Pipe it just like any other boiler...

The Glitch:

The Fix:

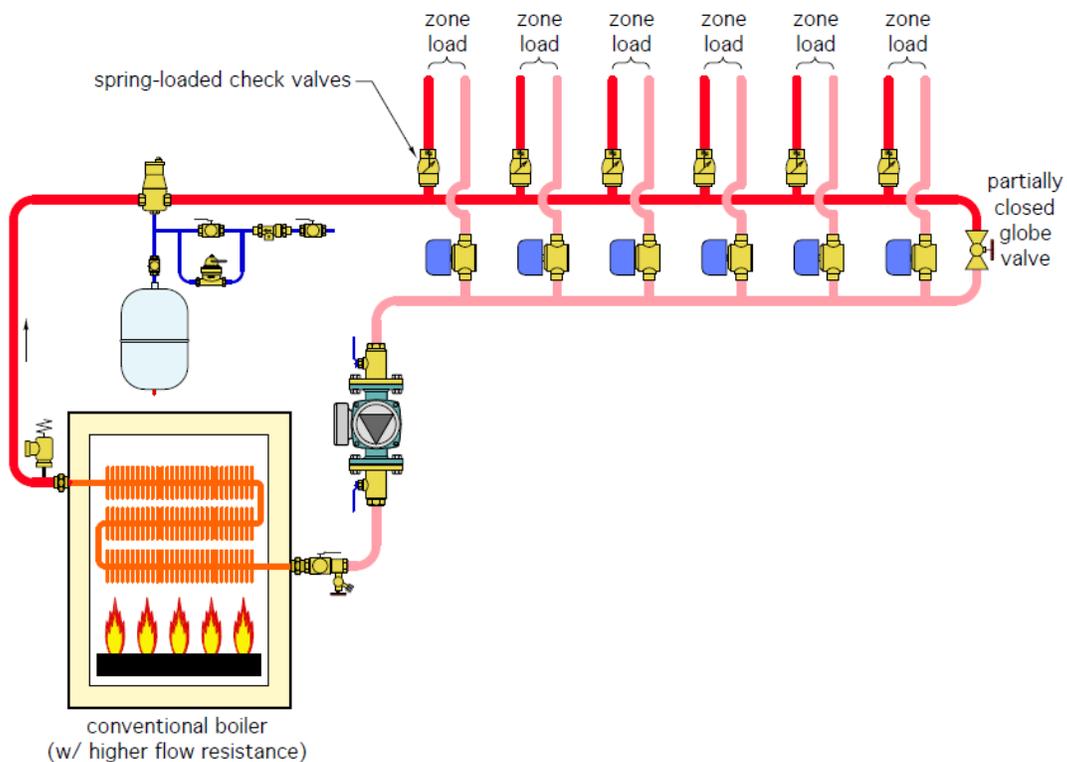
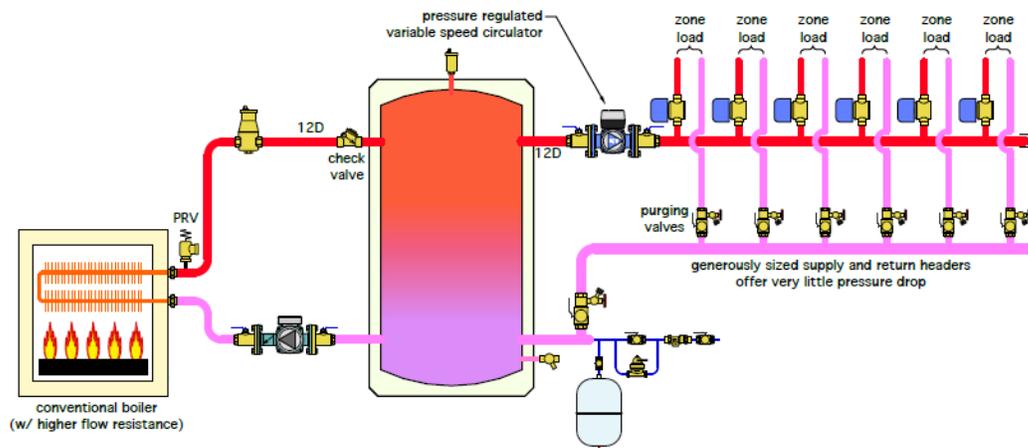
An installer sets up a zoned distribution system as shown below. To keep it simple, he uses the same size piping for the headers and all the distribution circuits. The heat source is a low-mass, copper-tube boiler with high-flow resistance. The distribution system operates at water temperatures high enough that sustained flue gas condensation will not occur.

To prevent heat migration, he installs a spring-loaded check valve at the beginning of each zone circuit, just above the header. To control differential pressure, he installs a partially open globe valve across the ends of the headers. He sets the globe valve for one-turn open.

Can you identify and describe at least six details that should be changed?

1. The high-flow resistance boiler will create significant variation in zone flow rates depending on which zones are open. The boiler's low thermal mass heat exchanger can create noises under low flow conditions when only one or two zones are operating.

2. The partially closed ball valve is a poor excuse for proper differential pressure control across the headers. A variable speed, pressure-regulated circulator is now the state-of-the-art method for providing such control in systems using valve-based zoning.

3. Headers should always be generously sized to minimize pressure drop along their length. This helps minimize flow rate variations as different zones turn on and off. I suggest headers be sized for a flow velocity not to exceed 2 feet per second under full design flow rate.

5. It's never a good idea to install check valves near fittings that create high turbulence. This is the case with the check valves shown on the supply side of zone in the glitch drawing. There should always be at least 12 diameters of straight piping upstream of any check valve to calm turbulence that otherwise can cause the disc side of the check valve to rattle. However, heat migration in this, the fix drawing, is eliminated by simply installing the zone valves on the supply side of the zone circuits. Do this and there's no need for check valves on each zone circuit.

6. Purging valves on each zone circuit are missing in the glitch drawing. They are shown in the fix.

7. The circulator location in the glitch drawing, in combination with the likely pressure losses of the piping system, puts the circulator in a “pumping toward” rather than “pumping away” situation with respect to the expansion tank. Installing the expansion tank near the lower inlet of the buffer tank keeps the point of no pressure change close to the inlet of both circulators.

4. Any "flow sensitive" boiler supplying a system using zone valves should be decoupled from the distribution system through some means of hydraulic separation. In the fix drawing this is accomplished with a buffer tank, which also adds thermal mass to prevent boiler short cycling.
